# Response

## 1 Anonymous Referee #1

Figure 1: Comparison of the three LAI estimation method tested on the green roof site.

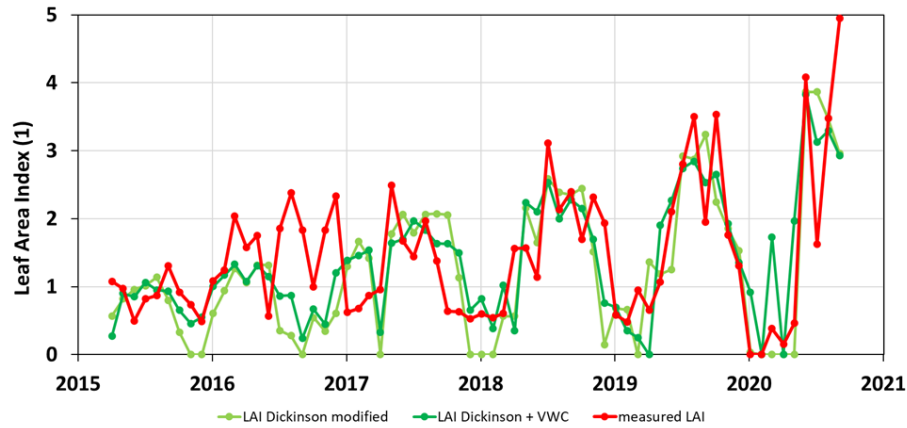
My previous comment on the implication of LAI quantification for the modelling study is critical. Would there be other ways to gather the LAI if one does not have access to these photos? How uncertain is the LAI quantification? Could you run some simulations to test the implications of such uncertainty? Simply referring to the paper by Heusinger and Weber is not enough. Especially considering that the aim is to have this model fully coupled to regional climate models.

The observed LAI is only used in the pre-calibration process and to roughly evaluate the modelling. Quantifying the impact of the LAI uncertainty on modelling would imply doing sensitivity test on the calibration process itself rather than on the final calibration. However some more details can be given on the LAI measurement. Estimation using RGB photo analysis is the 'reference method' for this type of site. But there are other ways to estimate the LAI, as investigated in a masters thesis which looked at modelling the green roof LAI by a semi-empirical function (just weather data) and an optimized version of it (containing substrate water content). The results can be seen on the Figure 1, they show that the LAI estimation for all 3 methods is quite similar.
